From: EPorter95@aol.com
Sent: Thursday, April 06, 2006 2:32 AM
To: Susan Harris
Subject: Comments on Draft Environmental Impact Report (EIR)
Attachments: BB4.ppt

Please accept my comments on the DRAFT ARANA GULCH MASTER PLAN
AND DRAFT ENVIRONMENTAL IMPACT REPORT

LETTER C15
Ed Porter

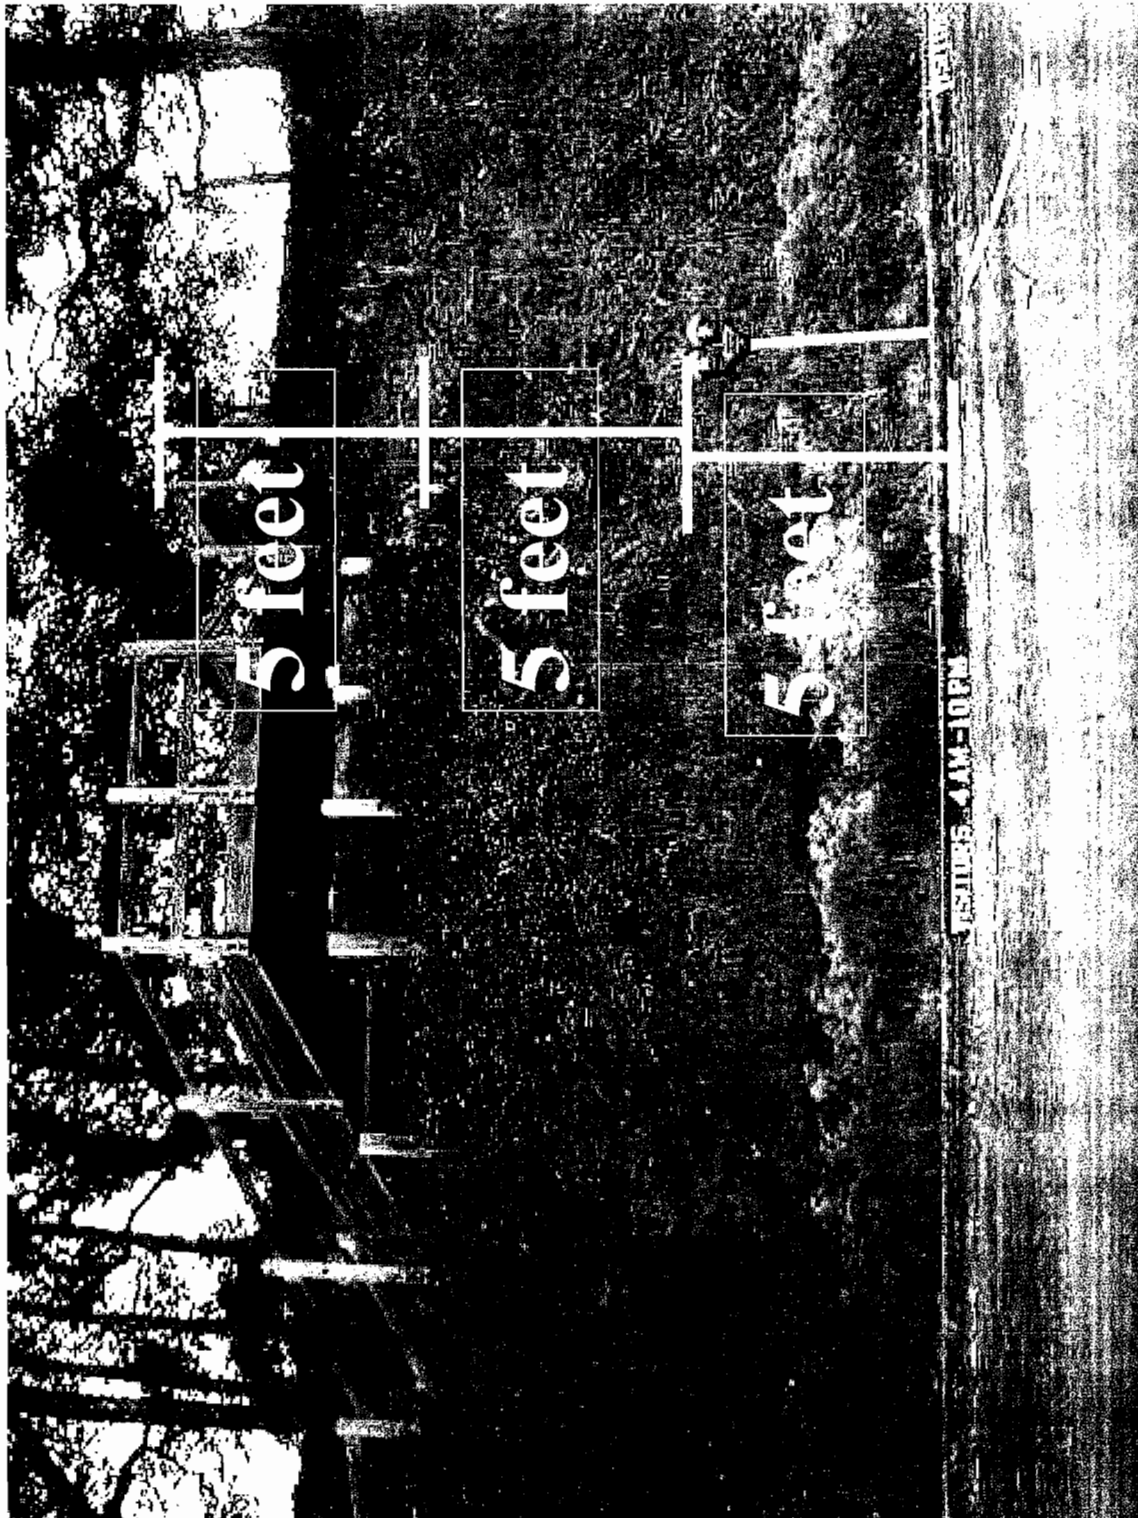
The Frederick Street Park route meets the goals of the project without the unavoidable environmental impact to Arana Gulch, costs about \$1,3000,000 less to build, and only adds about 164 additional minutes to the bicycle travel time over the D2 route. As evidenced by the public commentary at the public hearing, the public clearly wanted the Frederick Street Park Route evaluated as a part of the EIR process.

Segment: Frederick St.
Total : 0.658 mi

Segment: Mod D2
Total : 0.379 mi

Response C15-1: Refer to Master Response No. 7 regarding an off-site alternative.

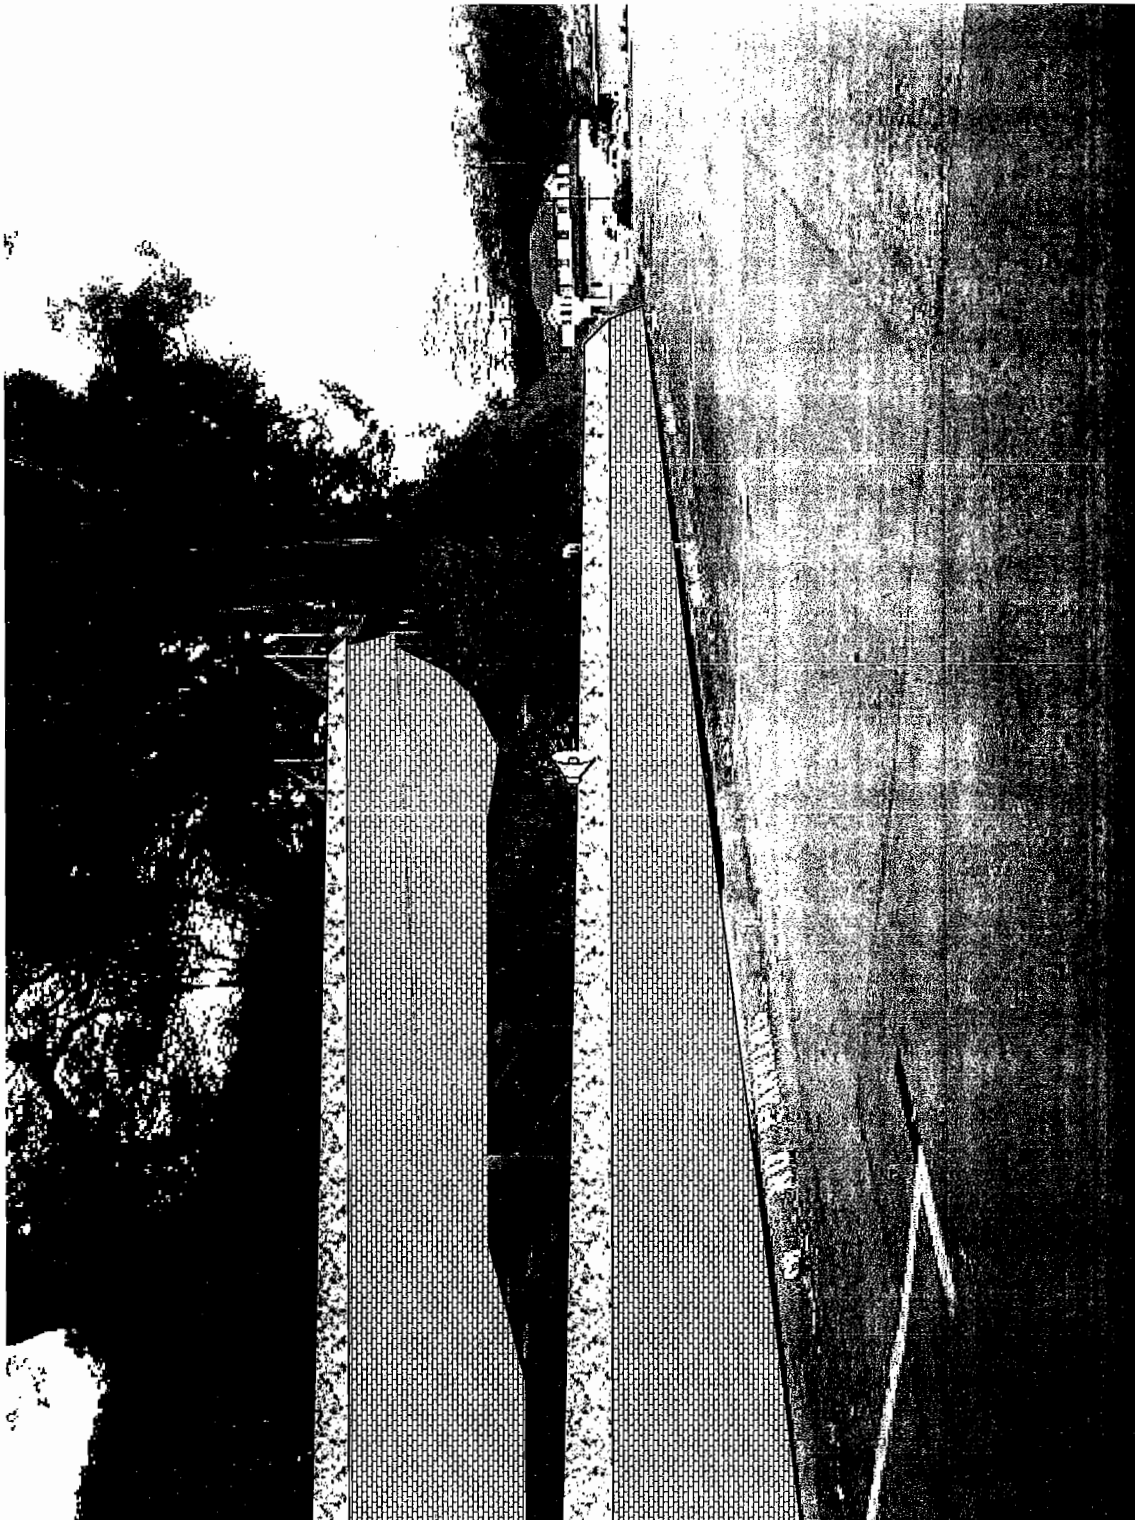
travel time

1.64 Minutes

Difference

ADA

Ramp & slope requirements

No Railing
